Our Ref: sjb/ECL.014.01.01/L001

Application Reference: EPR/NP3433BC/V005
Operator: Convatec Limited
Installation: Convatec Rhymney Gelling Fibre Plant

Further to your Schedule 5 request for further information, I am pleased to provide the following response.

Please find appended drawing 5-LTJ-6779 detailing all emission points.

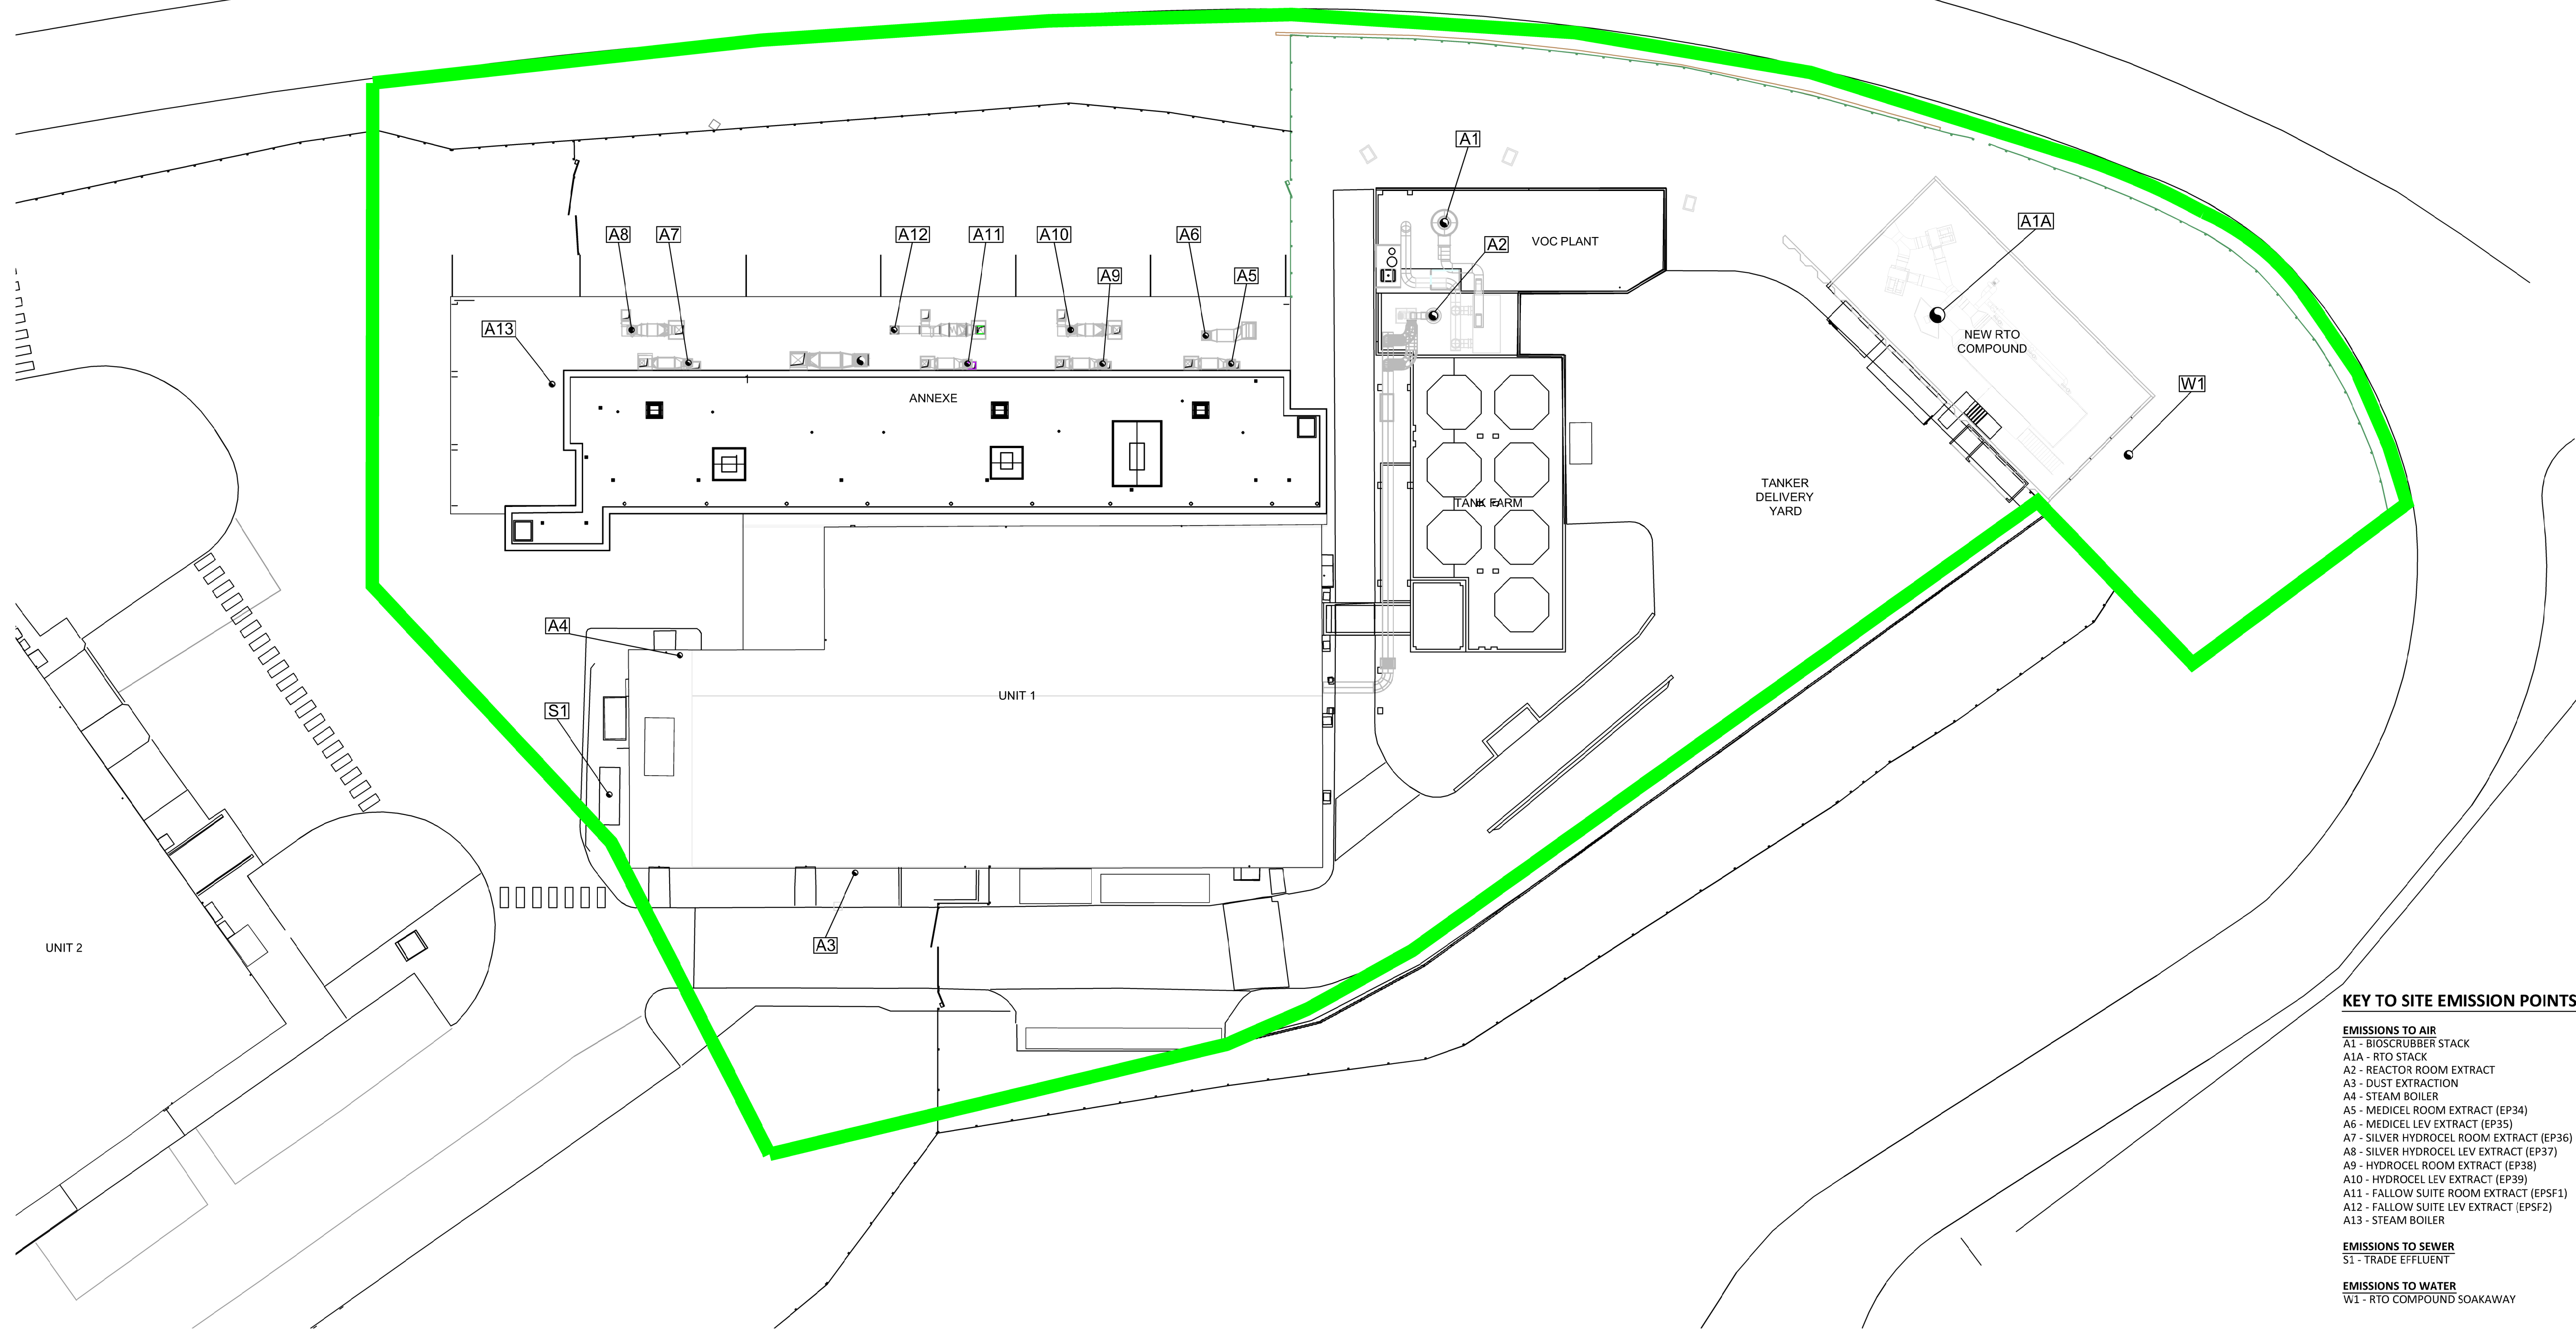
2. Emission Points
